SERVICE BULLETIN

M-940

CHANGES FOR 1987 SOFTAIL VEHICLES

Figure 1. Harness Routing and "T" Bracket Bolt

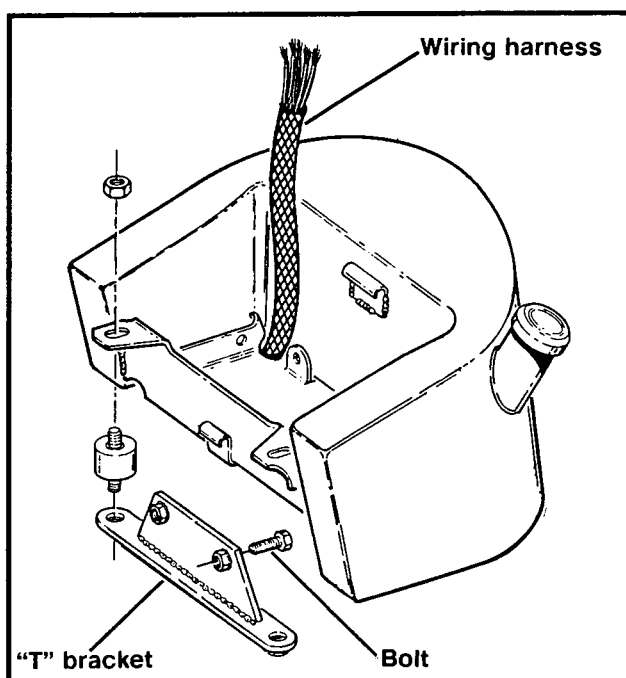
Harley-Davidson has changed the routing of the frame seatpost wiring harness. It is now routed inside the oil tank.

See Figure 1. Some vehicles were assembled with the incorrect oil tank "T" bracket bolts. 3974H was used instead of 4391. 3974H is too long. Your customer may complain of a metallic "clunk" if the suspension bottoms. If this happens, remove the 3974H bolts and replace them with the 4391 bolts. Change the 1987 Parts Catalog to reflect this change.

See Figure 1. During routine maintenance, disconnect the wiring harness and re-route it inside the oil tank.
